Peer Urban Design Review

1-5 Chester Street Annandale

Project and report	1-5 Chester Street Annandale	
Date	July 15, 2019	
Client	Inner West Council	
Document no.	K:\190216.00\Docs\C_Client	
Version and date issued	Issue A (Stage 1 - Draft to Council) - 21/06/19	Approved by: Oscar Stanish
	Issue B (Stage 1 - Draft to Council) - 01/07/19	Approved by: Oscar Stanish
	Issue C (Final issue) - 15/07/19	Approved by: Oscar Stanish
Report contact	Oscar Stanish Associate, Urban Design	
This report is considered a draft unless signed by a Director or Principal	Approved by:

Ground plan showing industrial units with out street frontage
(Extracts from Urban Design Report May 2019 by ae design partnership)

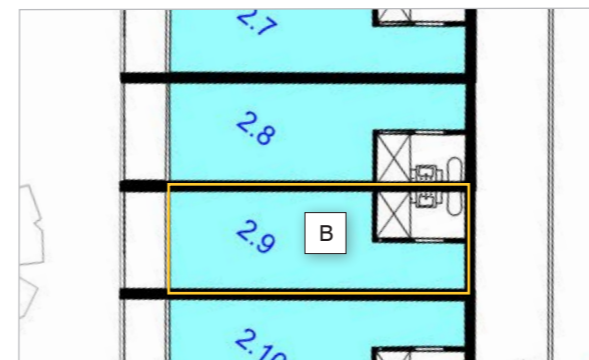
Issue	Appropriateness of May 2019 proposal	Justification	Preliminary recommendation
Land use	<p><u>Urban Design</u></p> <ul style="list-style-type: none"> The proposed typology for a mixed use building is atypical and not considered appropriate. The proposed industrial uses which are individual 'creative offices' have limited street frontage and appear more as home offices. There is also no large vehicle access to service these uses [A] Compatibility of residential uses and industrial uses in this form may cause land use conflicts (as described further under Bulk and form). The boarding house unit sizes (approx min 18sqm) are similar to what is being delivered across Sydney. The amount of communal space is acceptable however no communal open space is not (further discussed in Open Space and Deep soil). <p><u>Planning</u></p> <ul style="list-style-type: none"> The proposed typology for industrial uses would not deliver on the state government and Council's vision for the Camperdown precinct or the objectives for the IN2 Light Industrial zone in LLEP2013. The proposed boarding house uses align with the PRCUTS recommended land use for the site however not with the proposed timeline. 	<p><u>Urban Design</u></p> <ul style="list-style-type: none"> Floorplates should be as flexible as possible to ensure buildings can respond to changes to market demand over time. Businesses generally require a street frontage and front door. Industrial floorspace and its ability to function should be protected. 15-20% of student housing FSR is typically for common areas SEPP (Affordable and Rental Housing) requires minimum 12sqm for single occupant boarding house. Example of boarding house unit in Sydney is shown below and compared to the proposal [B] <p><u>Planning</u></p> <ul style="list-style-type: none"> The Parramatta Road Corridor Urban Transformation Strategy (PRCUTS) in conjunction with the Greater Sydney Regional Plan and the Eastern Harbour City District Plan underline the importance of the Camperdown Precinct as part of the Camperdown Ultimo Collaboration area with a focus on the biotechnology sector. While the PRCUTS recommends that the site be zoned R3 Medium Density Residential (with a focus on key workers, affordable housing and student housing), the site is not proposed for residential development until after 2023, as it is outside the boundary of the PRCUTS Implementation Plan for 2016-2023. The proposed typology would be unlikely to meet the objectives of the IN2 Light Industrial zone in the LLEP2013, such as 'to support and protect industrial land for industrial uses'. 	<ul style="list-style-type: none"> Architectus is not opposed to a mix of uses on the site (including residential uses) provided that the site can: <ul style="list-style-type: none"> deliver the employment uses envisioned for the Camperdown Precinct ensure residential uses are well separated to prevent compatibility issues that would detract from the future employment potential of the precinct. Architectus is however concerned with the proposed mixed use typology which is atypical. The model should be checked, as from Architectus' experience: <ul style="list-style-type: none"> Industrial uses prefer to have flexible large floorplates and street frontage. A large industrial floorplate also allows residential uses to be well separated. Council should know that a final design could vary considerably and be satisfied appropriate controls will ensure a high quality boarding house outcome. Council should seek to be satisfied that the uses proposed are the right typology which can be delivered on the site, achieve the vision for the Camperdown Precinct and provide flexibility to meet future needs.

Section of proposal showing difference in terrain level either side of the creek (Extract from Urban Design Report May 2019 by ae design partnership)

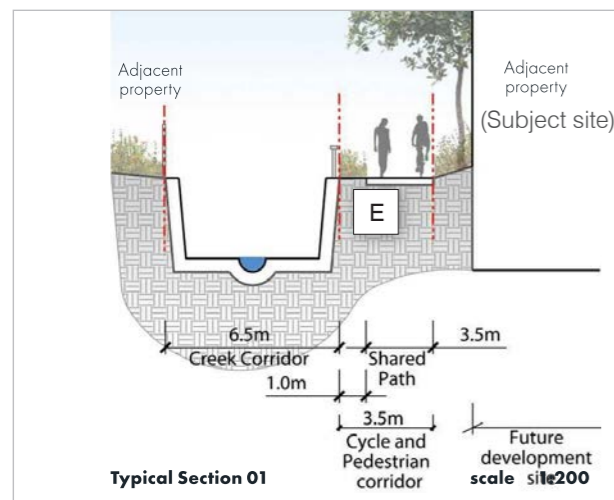
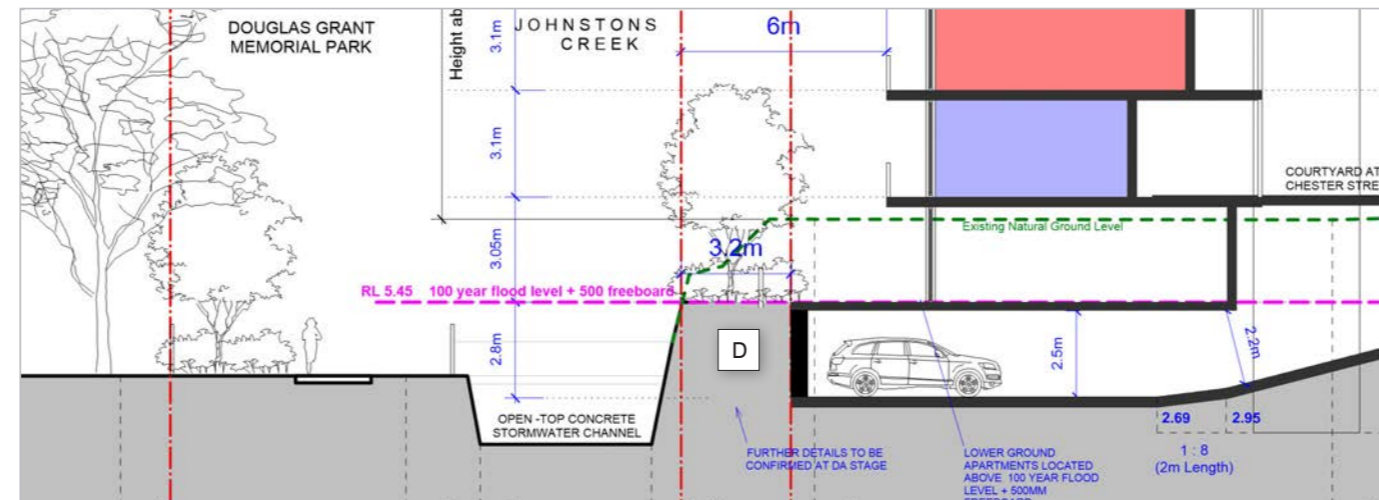
Slope and levels	<ul style="list-style-type: none"> The terrain level on the Johnstons Creek frontage is lifted up to RL 5.45 to be above the 100 year flood level (according to the section), which is approx 2m higher than the terrain level on the opposite side of the creek [D]. This is not appropriate as it results in a poor interface with the creek and the properties west of the creek including Douglas Grant Park. 	<ul style="list-style-type: none"> Developments should optimise the interface with the natural environment. By lifting the terrain, the difference in topography either side of the creek is exacerbated. The site feels disconnected from the creek frontage and its neighbours. Douglas Grant Park is a key local public space and it is important that adjacent properties contribute to providing an attractive frontage to this space with good passive surveillance. Council's proposed shared path shows the same terrain level either side of the creek [E] Note: There is an inconsistency in ground heights between the section shown and the render. The render appears lower as the basement carpark is visible [F]. 	<ul style="list-style-type: none"> The terrain on the Johnstons Creek frontage should be lowered to match the terrain height of the properties and park west of the creek, as per Council's Section of the proposed share path and thus provide a better interface with the creek. Note the basement level of the development needs to be appropriately screened so it doesn't provide a blank wall to this frontage.

The terrain on the Johnstons Creek frontage should be lowered to match the terrain height of the properties and park west of the creek, as per Council's Section of the proposed share path and thus provide a better interface with the creek. Note the basement level of the development needs to be appropriately screened so it doesn't provide a blank wall to this frontage.

Basement plan highlighting tight turn at the bottom of the ramp

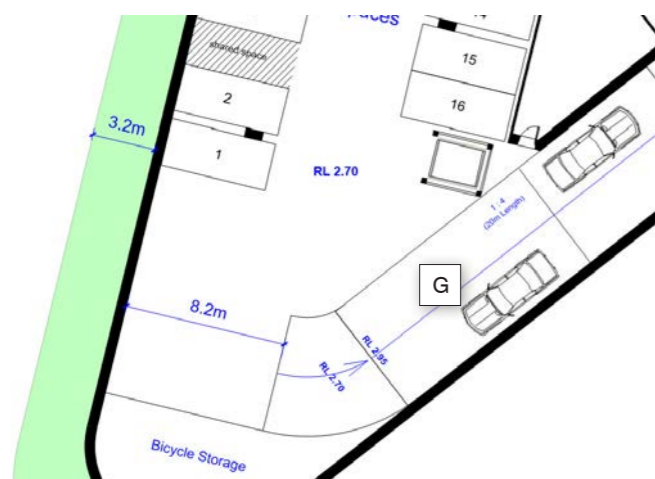
Movement and access	<p><u>Pedestrian</u></p> <ul style="list-style-type: none"> The proposed 'creative office' units should be accessed from the Chester Street frontage as this is the primary frontage for the development. <p><u>Vehicular</u></p> <ul style="list-style-type: none"> The turn at the bottom of the carpark ramp seems very tight and if the carpark is to be setback 6m from the Johnstons Creek frontage that will most likely not work. [G] It is noted, it may be acceptable for the basement to step out into the setback below basement level. The proposal does not provide include truck access. 	<ul style="list-style-type: none"> Industrial uses prefer street frontage and front door. Industrial uses require truck access to site. 	<ul style="list-style-type: none"> The industrial units typology should be reviewed (as described under Land Use) and ensure the industrial uses have a primary frontage and can be accessed from Chester Street. Configuration of carpark should be revised.

The below floorplans have been redrawn by Architectus to calculate floorspace in the May 2019 proposal

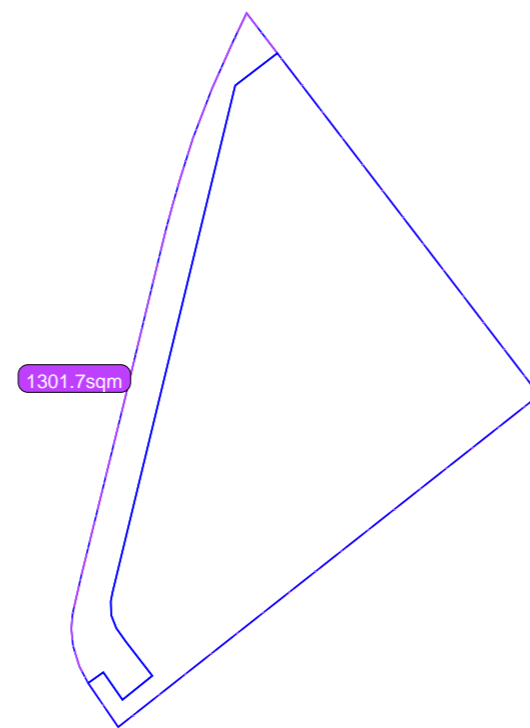
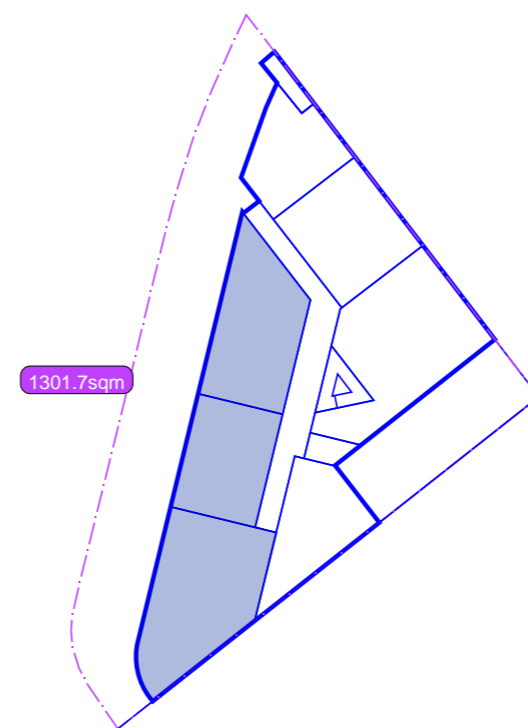
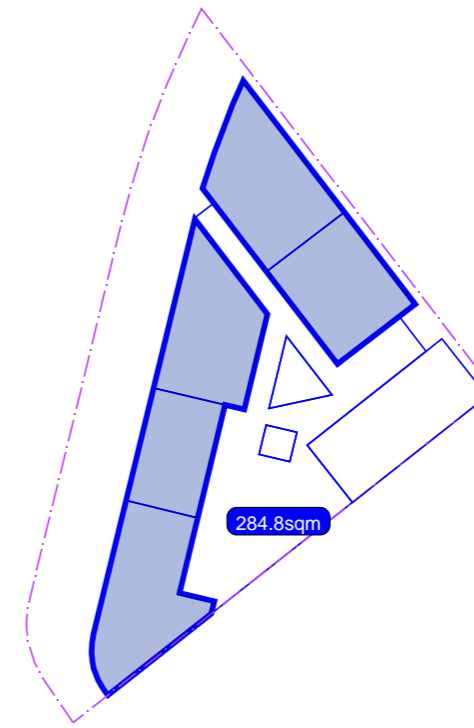
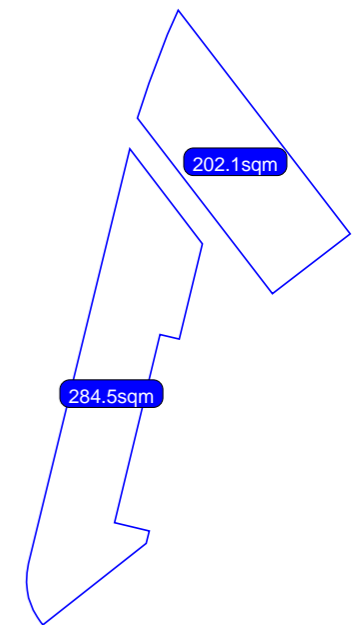
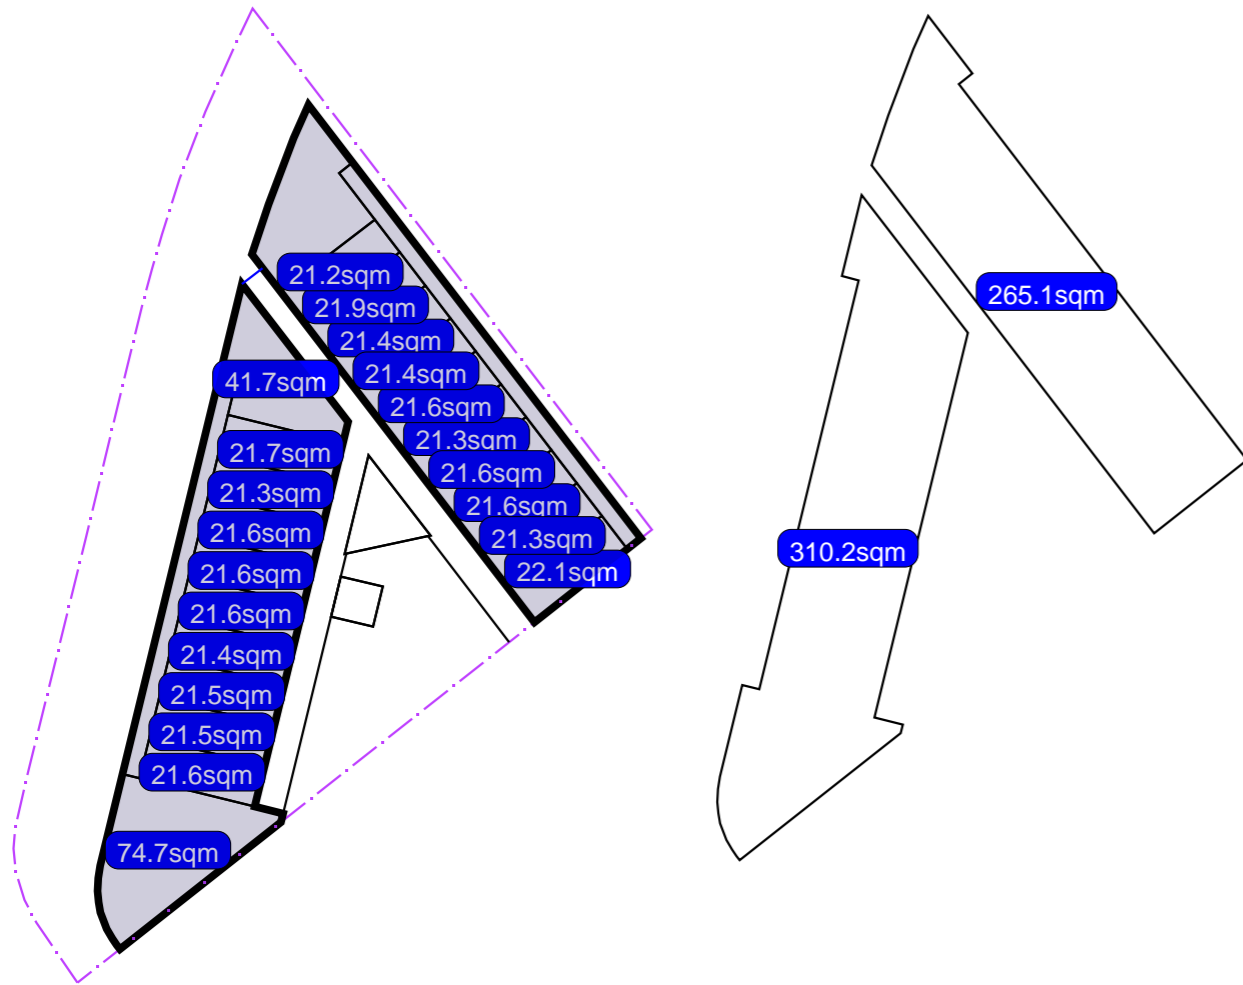
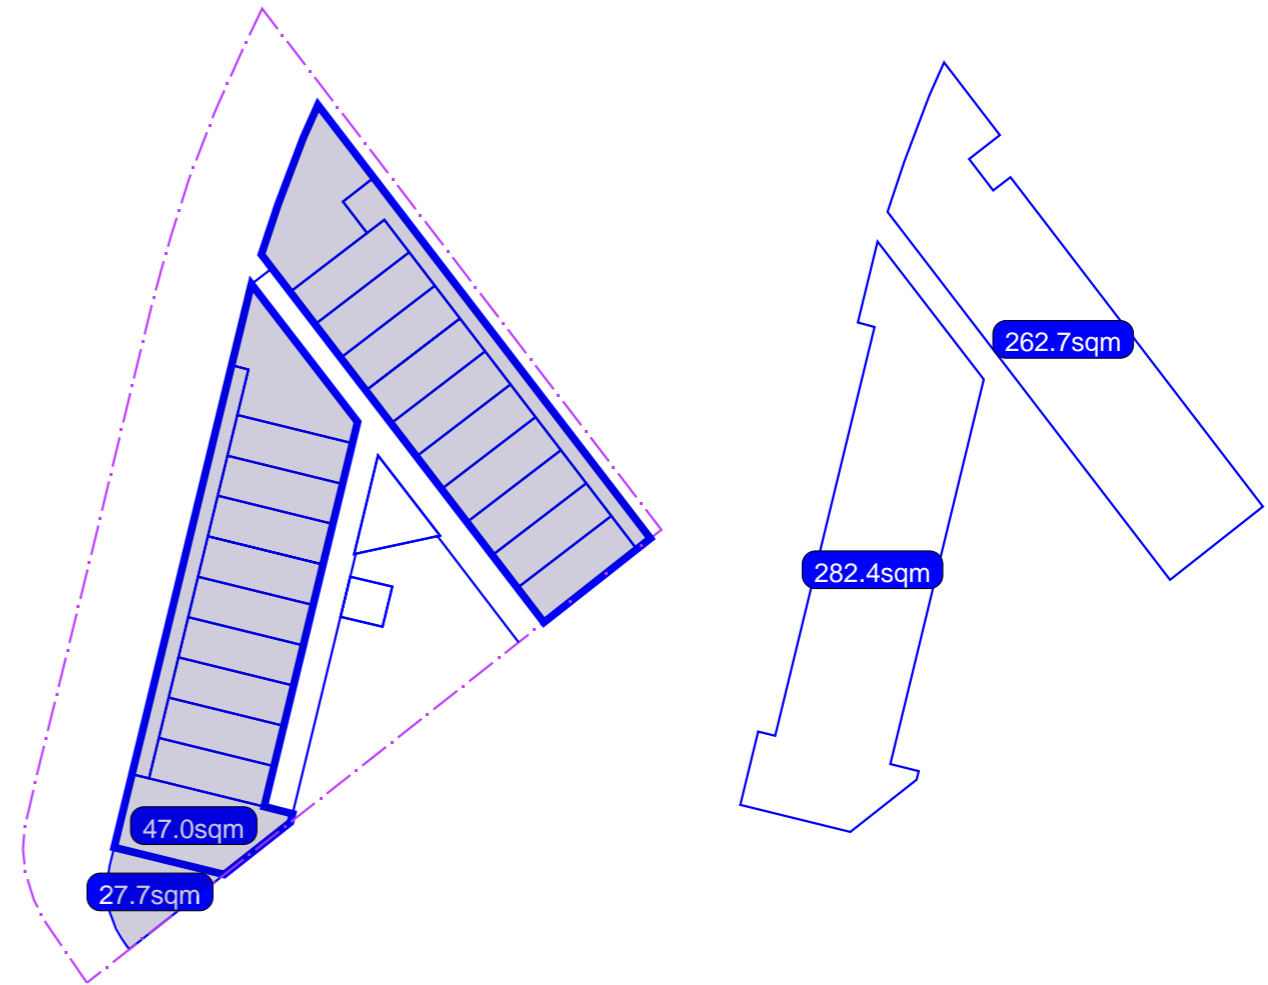
Total FSR: 2.5: 1

non-residential FSR: 0.86: 1

boarding & ancillary uses FSR: 1.67: 1

The proposed total FSR is not being achieved under the current scheme, according to Architectus' testing. Architectus recommends that the applicant provides a schedule so the calculations and be checked.
